FCT Assembly Solves Bridging Issues at Reflow

Tuesday, March 27, 2012

MLP 12-Pin

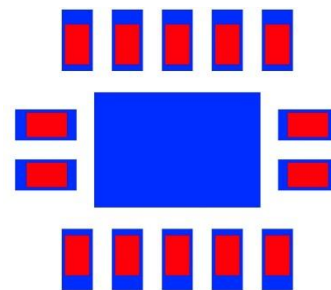
Just recently, Bob Dervaes, V.P. of Technology, performed a post reflow analysis on an assembly having bridging problems at reflow. The MLP 12-pin and SOT762 14-pin components, below, were bridging from termination-to-termination and from termination to the center GND/thermal pad, requiring post reflow rework.

For the bridging from termination-to-GND, the smallest clearance between the land pads for the terminations and the center GND pad is 0.006" for the MLP and 0.007" for the SOT762. This clearance is extremely small and can easily be bridged as the solder paste heats up and spreads during reflow.

The bridging from termination-to-termination is a result of stencil apertures that are too wide. The assembly has 1 oz copper, prior to through-hole plating, on the outer layers. There will be a size reduction, at the top of the PCB land pad, due to the copper etching process. For 1 oz copper, the reduction will be between 0.002" and 0.003". If the stencil aperture width is not reduced accordingly, solder paste can squeeze out between the stencil and PCB and create bridging on fine pitch devices.

To eliminate the bridging, the clearance between the solder paste bricks on the termination land pads and center pad needs to be increased. The stencil aperture width also needs to be decreased to compensate for the land pad size reduction, due to etching. However, solder volume is extremely critical on small components and large reductions in the width can cause insufficient solder volume problems at reflow. The stencil aperture length needs to have a corresponding increase to ensure sufficient solder volume. For leadless components, length should always be increased on the outer edge of the PCB land pad. Increasing the length to the inside increases the possibility of flux migrating along the component body, causing bridging.

- MLP 12-Pin: 0.0295" x 0.015" (40% volume reduction for thermal pad)
 - Stencil apertures shifted 0.002" to the outside to increase the clearance between the solder paste bricks and the center GND pads
 - Clearance between the solder paste brick and center pad is a minimum of 0.0125"
- SOT762 14-Pin: 0.030" x 0.009" (40% volume reduction for thermal pad)
 - Stencil apertures shifted 0.0027" to the outside to increase the clearance between the solder paste bricks and the center GND pads.
 - Clearance between the solder paste brick and center pad is A minimum of 0.0093"
